# UNITED STATES PATENT AND TRADEMARK OFFICE

APPLICATION NO.	FILING DATE	FIRST NAMED INVENTOR	ATTORNEY DOCKET NO.	CONFIRMATION NO.
09/627,637	07/28/2000	Kenichi Oinoue	P/3541-6	2855

**Office Action Summary**

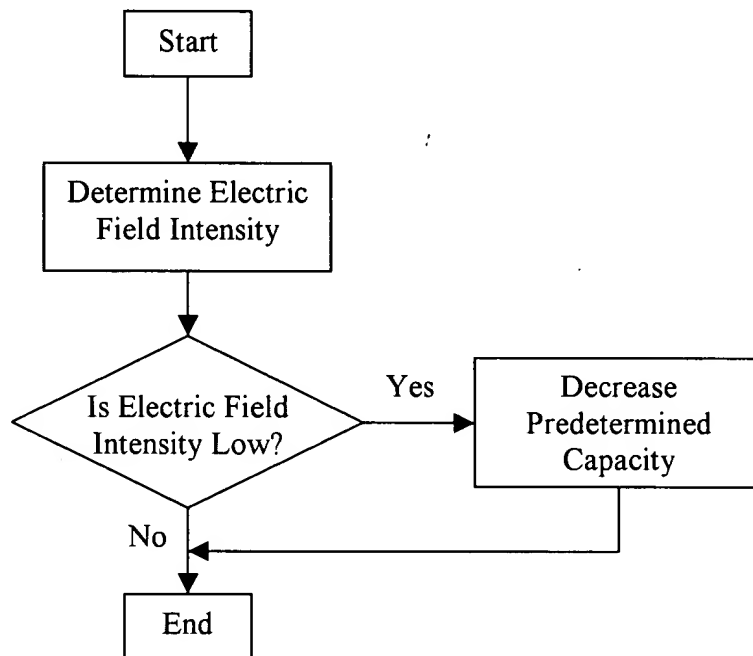
In order to overcome this rejection the Examiner suggests amending claim 9 to read “said transmission control means includes judgment means to judge the capability of transmitting the recorded information to a nearest communication base station, and said setting means decreases the set memory capacity when said judgment means judges that there is a low capability to

transmit the recorded information.” Examiner suggests similar amendments to claims 10 and 17-20.

Should Applicant adopt Examiner’s suggestions with regards to the claims, the Examiner further suggests that the Applicant add a further figure so as to show the limitations above. The Examiner suggests submitting a flow chart similar to the one illustrated bellow.
